Process Sheet

Customer	: CU-DAR001 Dart Helicopters Services	Drawing Name	: HELI UTILITY BASKET LH/RH 350/355
Job Number	: 31413		
Estimate Number	: 10208		
P.O. Number	: <i>N/A</i>	Part Number	: D350607043
This Issue	: 3/21/2007 S.O. No. : <i>N/A</i>	Drawing Number	: D350-607 REV F P7-9
Prsht Rev.	: NC	Project Number	: N/A
First Issue	: <i>N/A</i> Type : LARGE FAB ASSY	Drawing Revision	: F
Previous Run	: 31324	Material	: <i>N/A</i>
Written By	: <i>[Signature]</i>	Due Date	: 4/10/2007 Qty: 1 Um: Each
Checked & Approved By	: <i>[Signature]</i>		
Comment	: Est Rev:E as Per DSI9318 06-01-24 JLM

DESIGN <i>CP</i>	DRAWN BY <i>CP</i>	DART AEROSPACE LTD HAWKESBURY, ONTARIO, CANADA	
CHECKED <i>[Signature]</i>	APPROVED <i>[Signature]</i>	DRAWING NO. DSI 9318	REV. A SHEET 1 OF 1
DATE 06.01.06		TITLE WASHER ADDITION	SCALE NTS
A	06.01.06	NEW ISSUE

DART SERVICE INSTRUCTION

Figure 5- Basket Replacement Parts
(D350-607-043 Heli-Utility-Basket™)

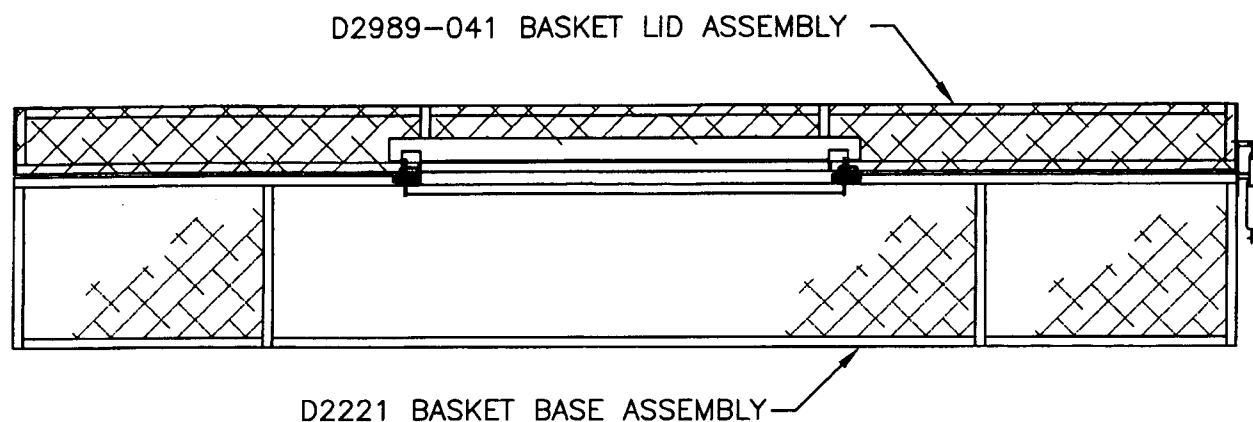
The corrected bolt stackup from Figure 5 of installation instructions D350-607 Rev. F is given below:

AN4-13A BOLT (1)
AN960JD416 WASHER (1)
HINGE PLATE (REF)
NAS1515H4 WASHER (1)
BASKET FRAME (REF)
AN960JD416 WASHER (1)
MS21042L4 NUT (1)
(2 PLACES)

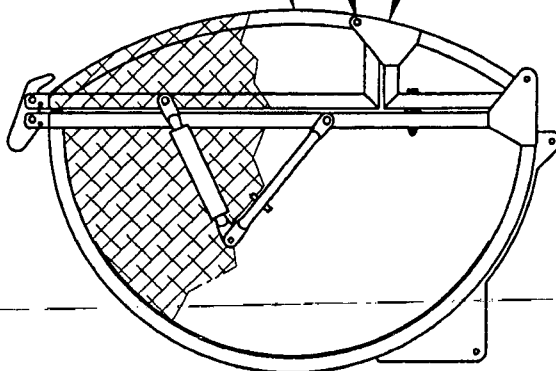
To reduce the possibility of damaging the finish, a **NAS1515H4** washer (2 places) has been added between the hinge plate and basket frame on the **D350-607-043/-047 Heli-Utility-Basket**.
